New Fairfield High School
State Project #: 091-0044N
Technology Equipment – Addendum #1
March 10, 2023

New Fairfield
High School &
Pool Locker
Rooms

ELECTRICAL DETAILS

3 TYPICAL VIDEO MONITOR DISPLAY / DIGITAL SIGNAGE ROUGH-IN DETAIL
N.T.S.

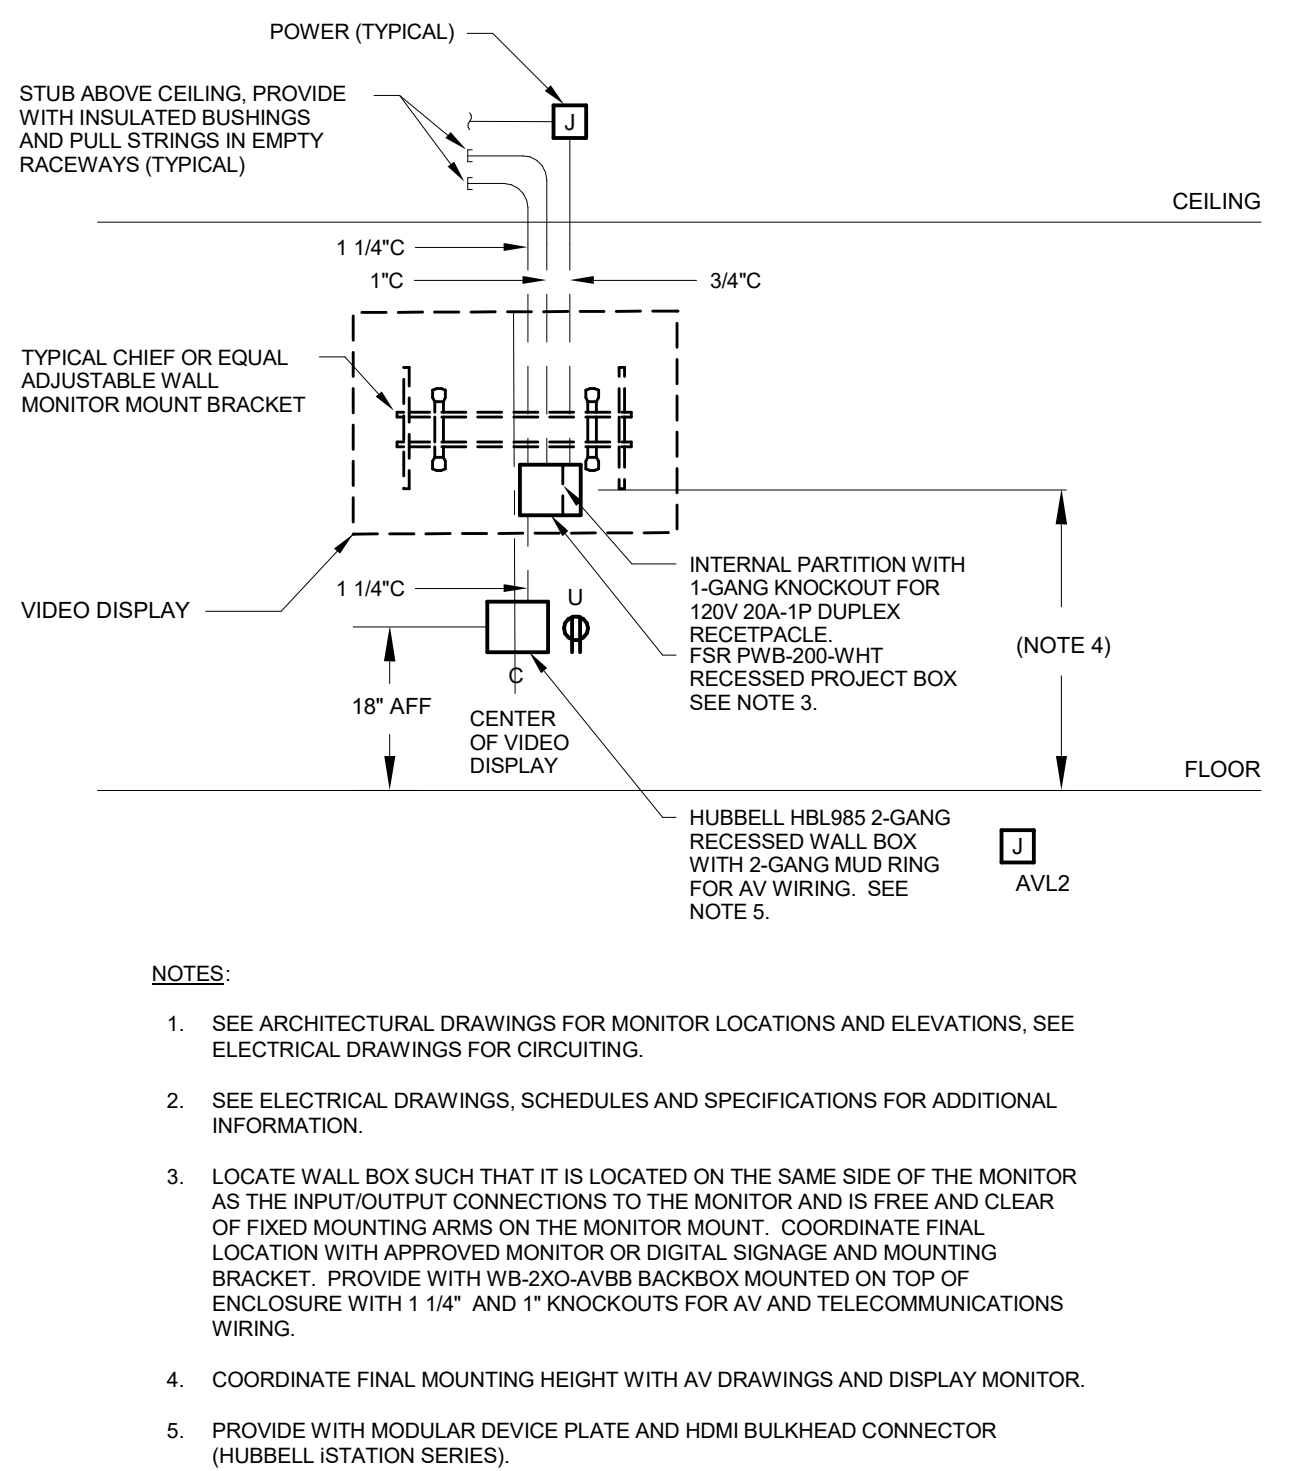
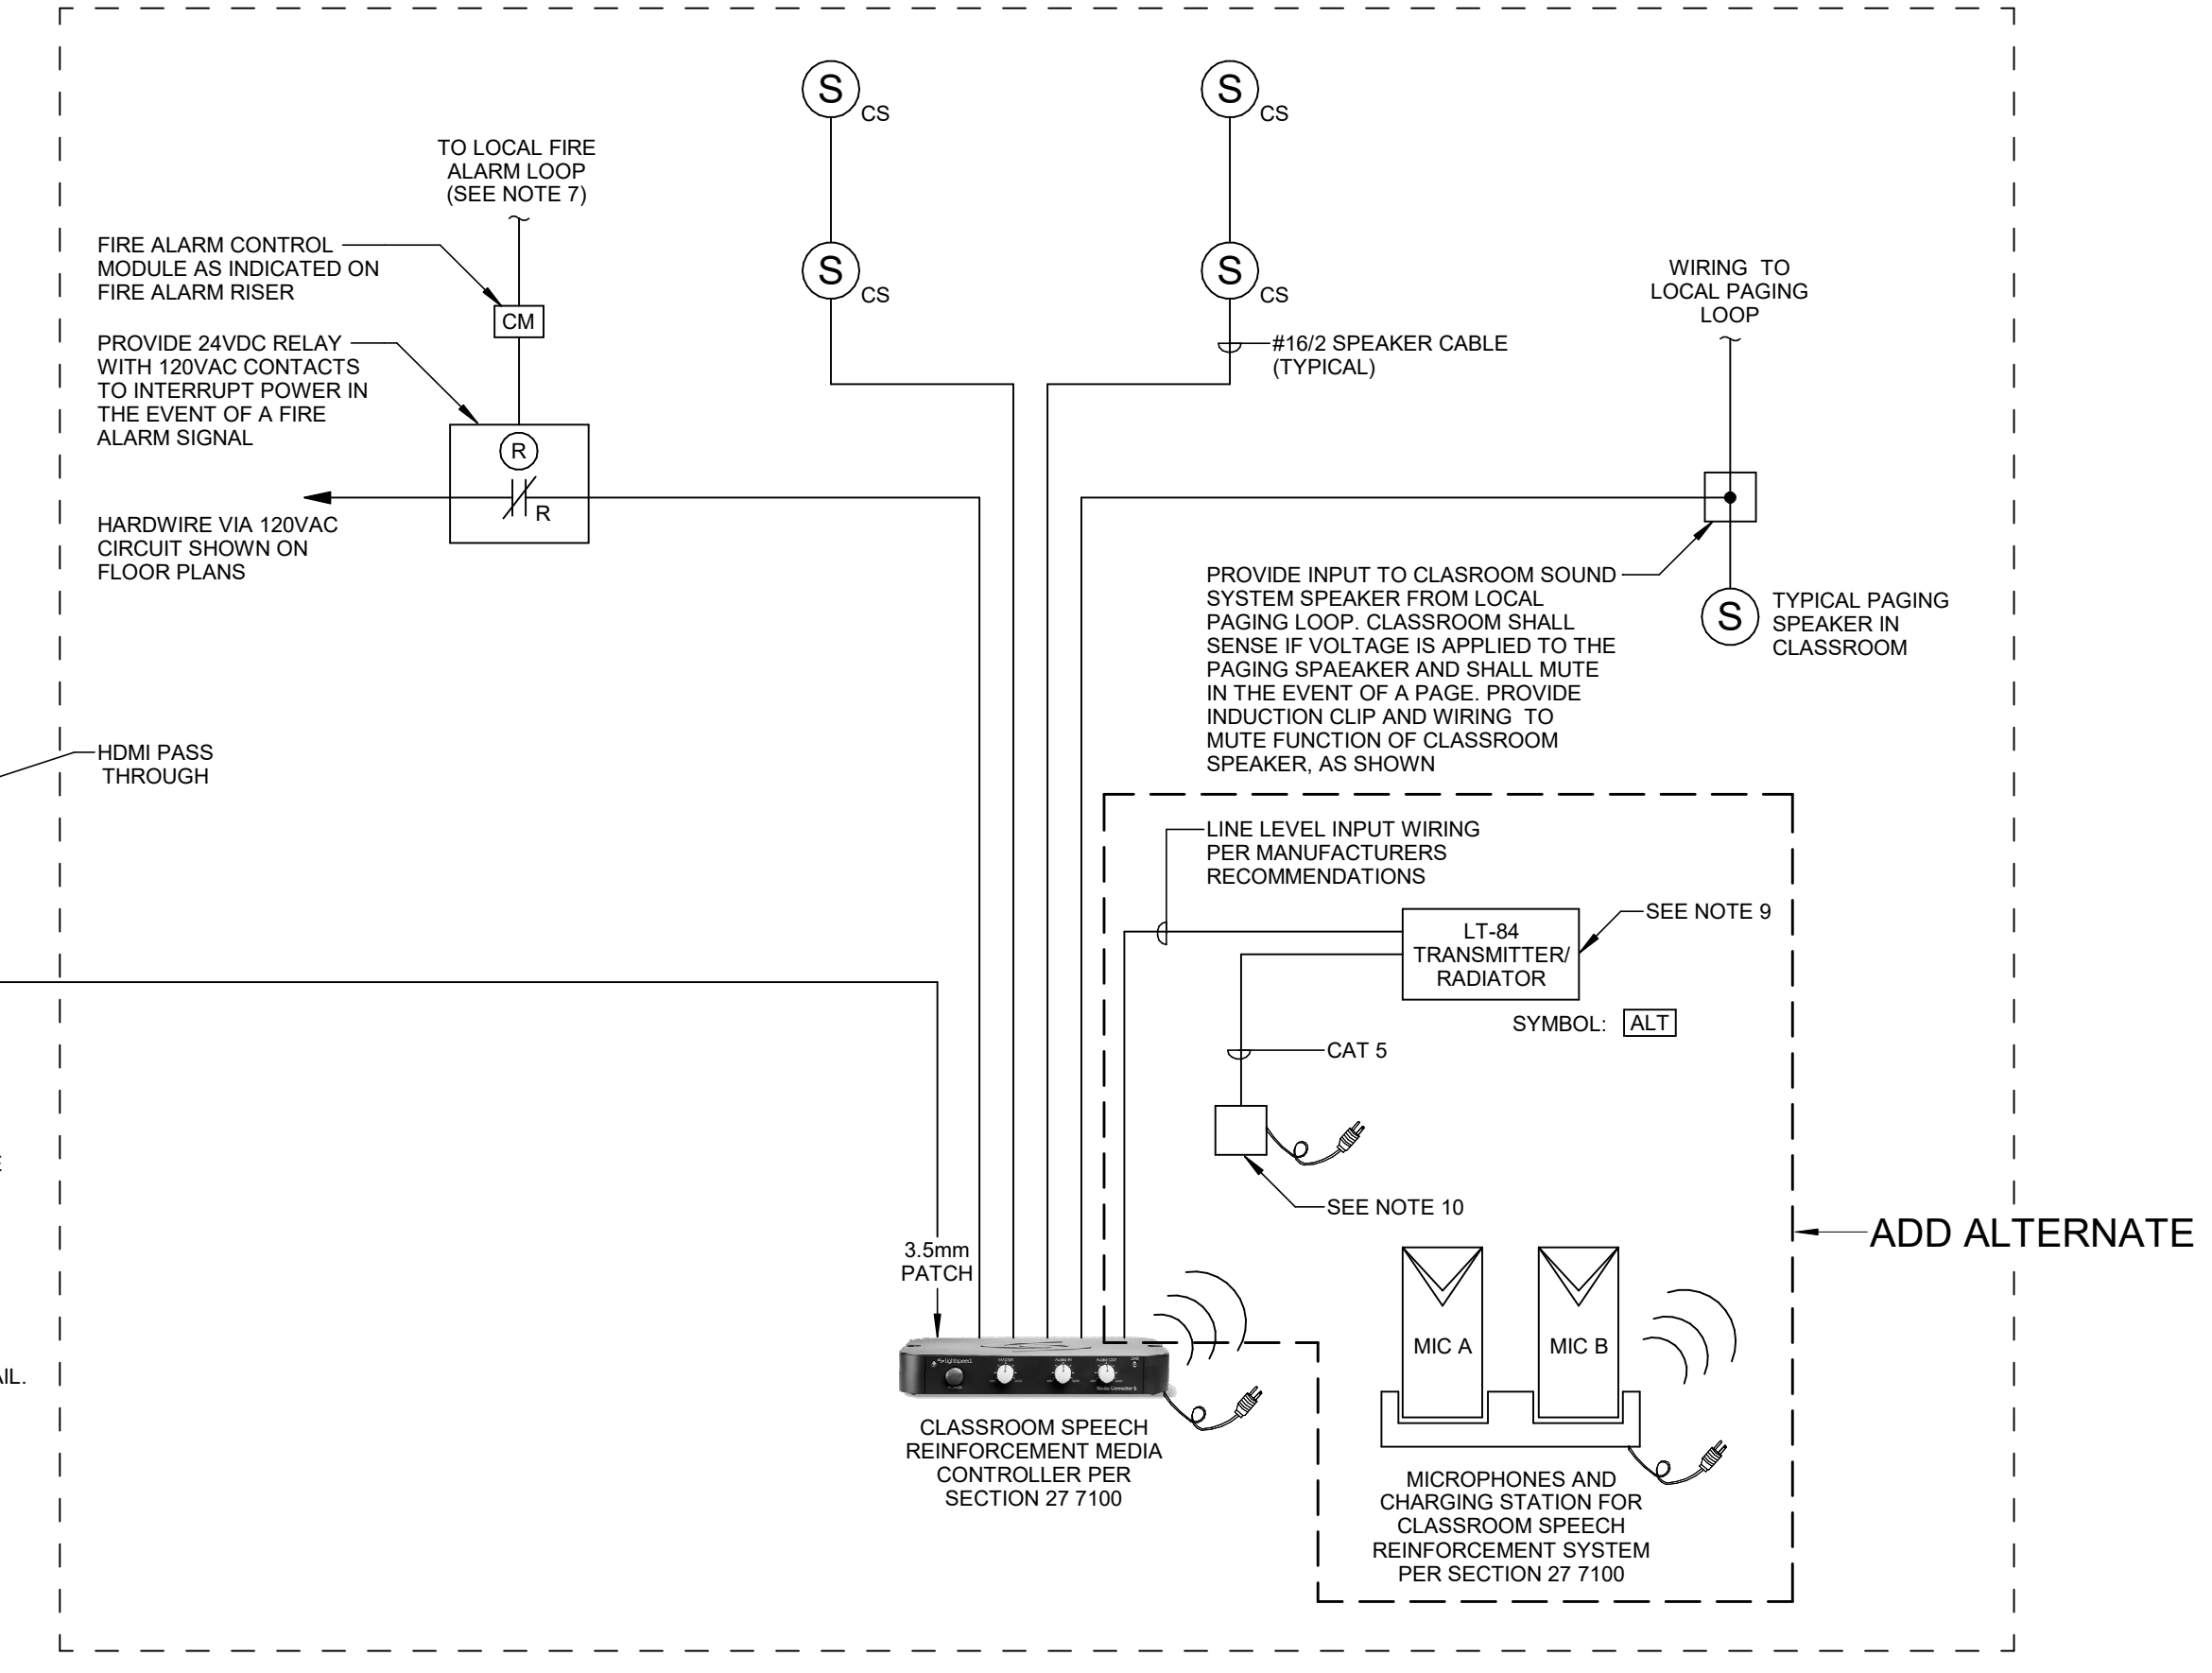
Q4: Can we please have a wiring diagram for TE1.1 - TE1.10

A4: *See attached sheet E-514 that is part of the base construction documents package.*
